# Work Order ID 92760

Item Name: Replacement Skidtube

D2580-041 ASSEMBLY DETAIL

DRAWING NO. D2580	TITLE 205 SKIDTUBE ASSEMBLY	REV. E	<b>DART AEROSPACE LTD ENGINEERING ORDER</b>	D.E.O. NO. D2580-E-1	SHEET NO. SHEET 1 OF 1	SCALE NTS
DRAWN <i>UP</i>	CHECKED <i>ASS</i>	MFG. APPR. <i>EC</i>	APPROVED <i>[Signature]</i>	DE APPR. <i>[Signature]</i>		
DATE 11.12.13	DATE 11.12.13	DATE 11.12.13	DATE 11.12.13	DATE 11.12.13

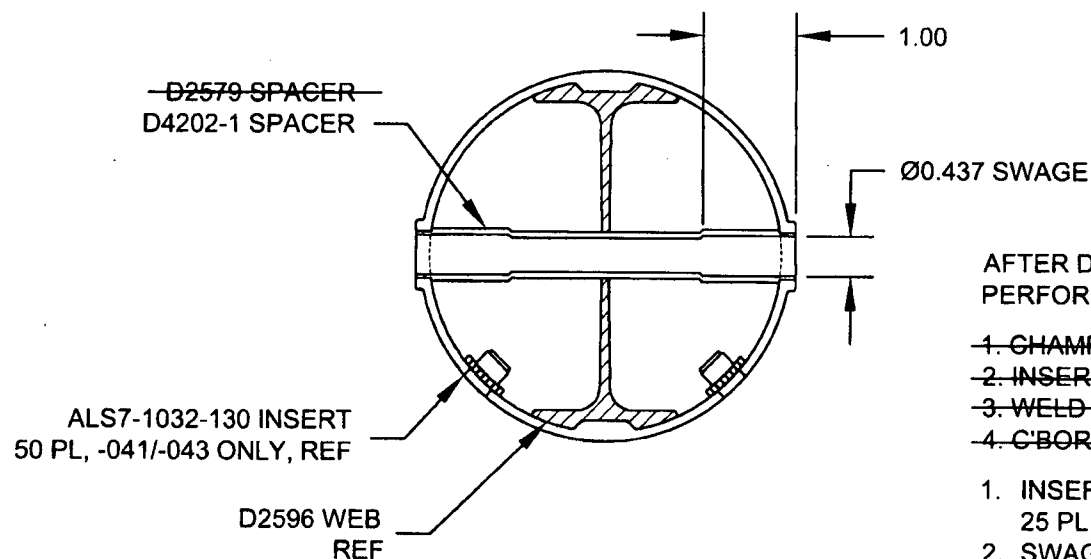
CHANGE ALL C'BORED WELDED CROSSBOLT SPACERS TO SWAGED SPACERS

QTY	QTY	QTY	PART NUMBER	DESCRIPTION
-041	-045	-047		
20	24	25	D2579	CROSS BOLT SPACER

4		* D2579	CROSS BOLT SPACER
20	20	25	D4202-1	SPACER

**\* FOR -045 SKIDTUBE ONLY:**

WELD 4X D2579 SPACERS PER DWG  
IN LOCATIONS MARKED "NO C'BORE".  
REF SHEET 4 OF DWG.
